## Report to Development Permit Panel

**To:** Development Permit Panel  
**From:** Cecilia Achiam  
Acting Director of Development  
**Date:** January 08, 2008  
**File:** DP 05-306672  
**Re:** Application by Matthew Cheng Architect Inc. for a Development Permit at  
7840 Garden City Road

**Annotated Excerpt from the Minutes from  
The Design Panel Meeting  
Wednesday, October 05, 2005 – 4:00 p.m.**

Matthew Cheng Arch.  
7840 Garden City Road

**ARBORIST MEMO**  
**7840 GARDEN CITY ROAD**  
**RICHMOND, BC**

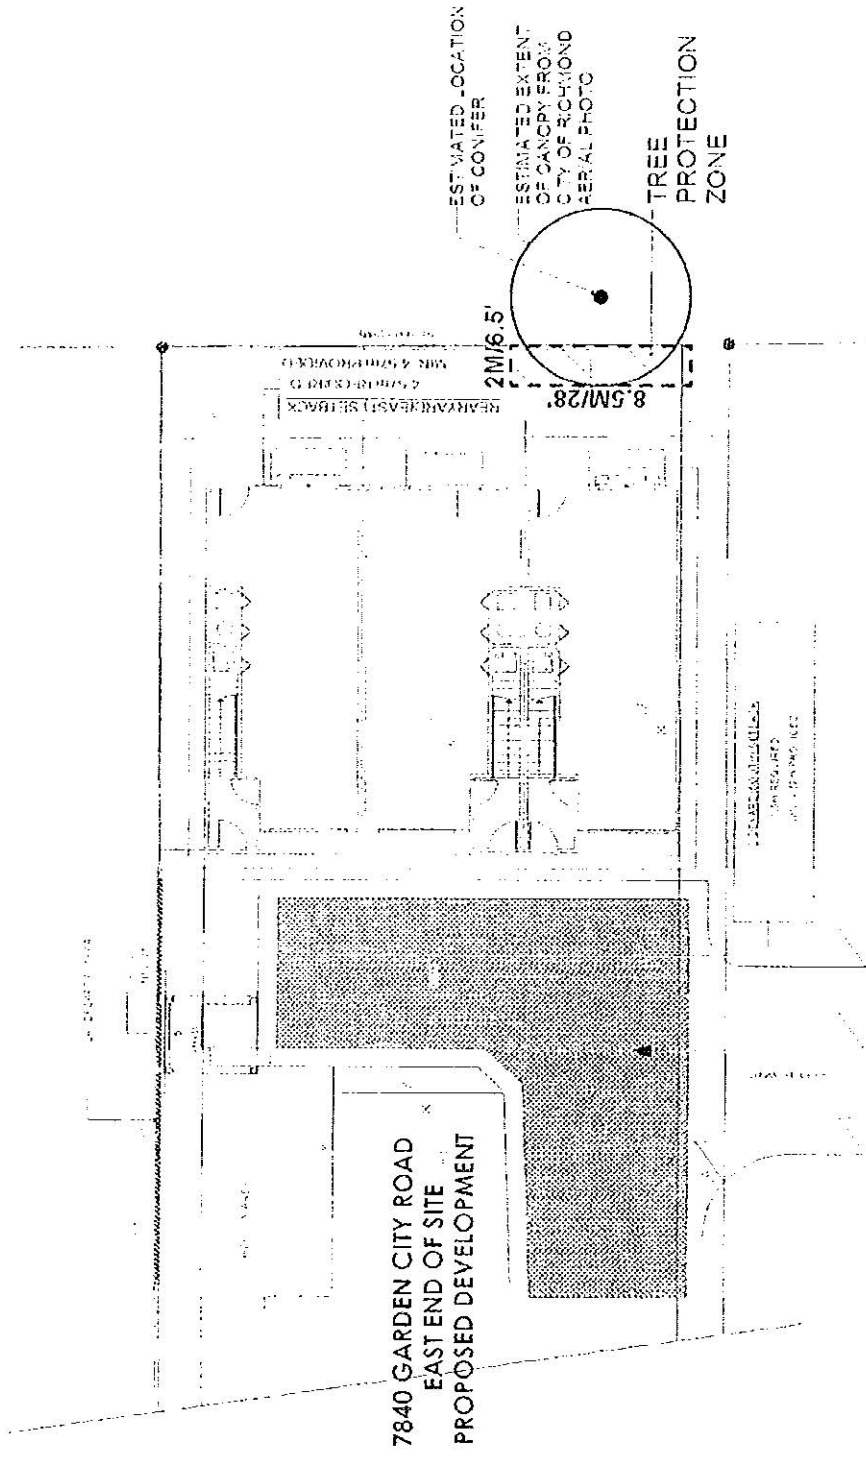
I recall seeing this tree while on site last February; this tree was retained during recent development and I observed that the tree is in decline. However, as it was not on the Topographic Survey, I did not take notes on the tree or photograph it specifically. I am surprised to see it now show up on a later Site Plan, and I believe it has been inaccurately depicted in size. From the City aerial photo, one can clearly see that the tree canopy is located well east of the east building line of the development to the north. I estimate that the canopy projects about half way into the 15' setback on the east side of the subject site. As such, I have recommended a Tree Protection Zone as shown on the attached drawing.

My opinion on this tree is that it has been adversely affected by construction (root cutting, compaction, alteration of drainage patterns around the tree root systems), and may well continue to decline. I recommend (as I do to any owner who has large conifers on their property), that it be inspected annually, or after extreme weather events.
